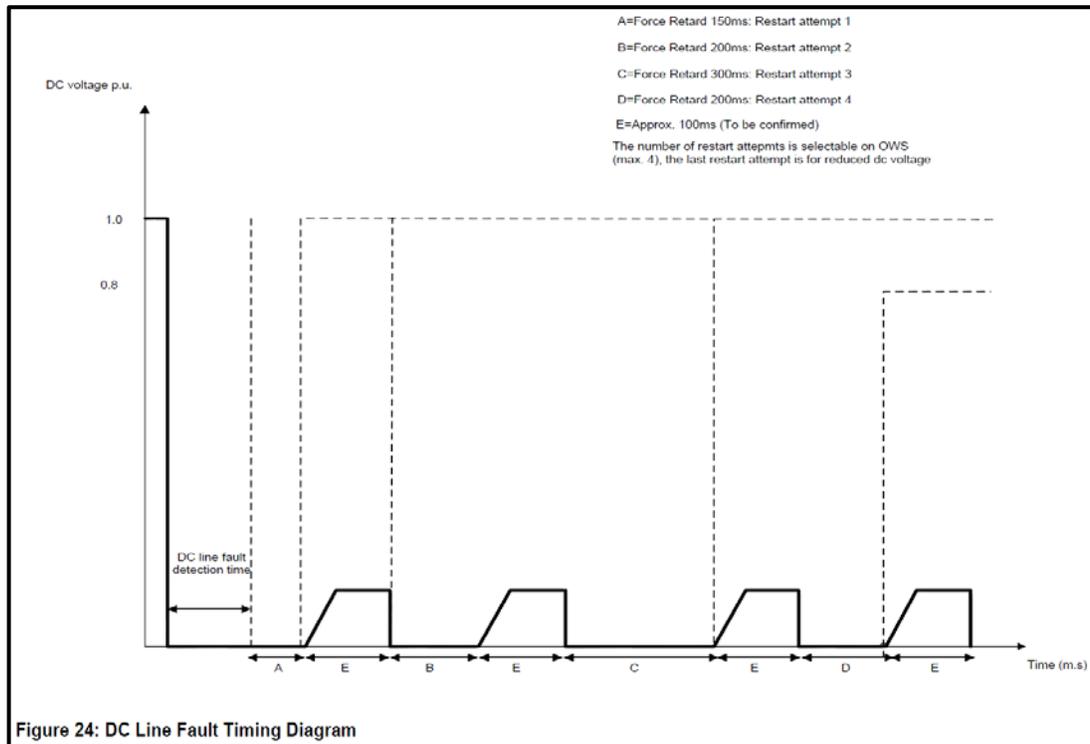
- 1 Q. None of the studies performed have considered the consequence of a restrike on
2 the HVDC OHL, as may occasionally happen. The scenario would be as follows:
- 3 1. Lightning strikes the HVDC OHL line (either just one pole or both poles –
4 both should be studied)
 - 5 2. The HVDC converter stops the current flow, waits for the preset re-starting
6 time, and then energise the line again.
 - 7 3. When the voltage reach say 90% the arc restrikes, and step 2 is repeated –
8 normally with an increased de-ionization time.
 - 9 4. Either the 2nd attempt is successful or a further attempt starting with a
10 lower dc voltage setting (say 80%) will be required.

11 Please perform such a study both for monopolar and bipolar operation. The
12 purpose of the study should be to identify the impact that these scenarios would
13 have on the performance of the ISS, and if relevant to identify the additional inertia
14 that would be required to protect the IIS.

18 *"Automatic restart attempts will only be enabled when fault occurs*
19 *on the overhead line. An operator facility will be provided to select*
20 *number of the restart attempts for overhead line faults. The*
21 *maximum restart attempt is 4 when the telecommunication is*
22 *available [4]¹.*

- 23 1. *The first restart attempt from the inception of the fault to the time when*
24 *power same as prefault DC power transfer of the Pole has been restored*

1 will occur in time E (Figure 24) time, including the time allowed for fault
2 deionization.

3 2. If the fault on the HVDC line persists after the first restart attempt, a
4 further restart attempts will be performed using an adjustable de-
5 ionisation period.

6 3. The last selected restart attempt will be carried out with reduced DC
7 voltage operation. For example: During the 1 pu DC Power in monopolar
8 operation, when the DC voltage order is at 0.8 pu and the DC current
9 shall be maintained at the prevailing DC current order which is 1 pu and
10 hence the DC power will be 0.8 pu [5]². The DC line fault restart attempt
11 will be inhibited if the next DC line fault attempt will exceed the
12 maximum calculated energy of the neutral surge arrester. The cooling
13 time of the energy dissipation for the neutral surge arrester will be
14 coordinated with the cooling curve of the neutral surge arrester. If the DC
15 line fault reappears again after recovery from the last attempt of the DC
16 line fault and the DC line fault is not inhibited, then the restart attempt
17 will be carried out as per normal strategy.

18 4. If the last attempt fails, the Pole will be blocked and tripped.

19
20 During the bipolar operation and HV line fault is detected, the Pole
21 associated to the HV line fault will start DC line fault sequence until the fault
22 is extinguished. The other Pole will take up the power up to the overload
23 capability until measure V_{dL} at the faulted pole recovers back to the pre-fault
24 DC voltage order.”

GE Grid will study examples of such dc fault scenarios for both monopole and bipole operation during the Dynamic Performance Study (DPS) in EMTDC/PSCAD. The results of the study will be provided in document, *Common - PSCAD Dynamic Performance Study Report*; doc# ILK-AS-SD-8200-EL-H99-0013-01. Nalcor Energy expects to receive first draft of report by June 30, 2016.
